Determination 2024/016

The issue of a notice to fix for building work associated with a two storey building with sanitary fixtures

10 Glenesk Road, Piha, Auckland

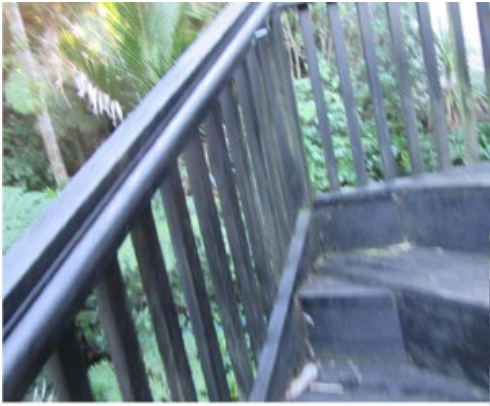
Item 1: “The installation of sanitary fixtures have not been connected to a wastewater treatment system contrary to clauses G1 (Personal hygiene), G13 (Foul water) of the NZ Building Code”	
The connection of sanitary fixtures to wastewater treatment system	<ul style="list-style-type: none"> As noted in paragraph 4.39, a building consent was granted for “connection to existing sewage system”, and a code compliance certificate was issued. The authority’s submission acknowledges that this item has been addressed, stating “We can confirm from a building code perspective only the works are now code compliant... This item will be removed from the notice to fix”. As sanitary fixtures have been connected to a wastewater treatment system under a building consent and a code compliance certificate has been issued, compliance with the Building Code has already been assessed.

Item 2: “The constructed stairway in this building is too steep, there is no compliant handrail and the barrier is not constructed correctly contrary to clause D1 (Access), F4 (Safety from falling) of the NZ Building Code”	
The stairway is “too steep”	<ul style="list-style-type: none"> The notice to fix states that the stairway is “too steep”. The authority submits neither the stairs, the handrail, nor the “landing” (ie the winding step at the top of the stairs, see Figure 3) comply with the Building Code clause D1 Access Routes, specifically subclauses D1.3.3(f), (j) and (m). This is because the risers are too high, there is an absence of a graspable handrail, and the “landing” is an inadequate size for footfall. The authority also states that the barrier to the upper deck area is non-compliant (measuring 930mm high). The risers (other than at the top and bottom of the stairway) are approximately 250mm and the treads are approximately 400mm, resulting in a pitch of approximately 32°. Acceptable Solution D1/AS1
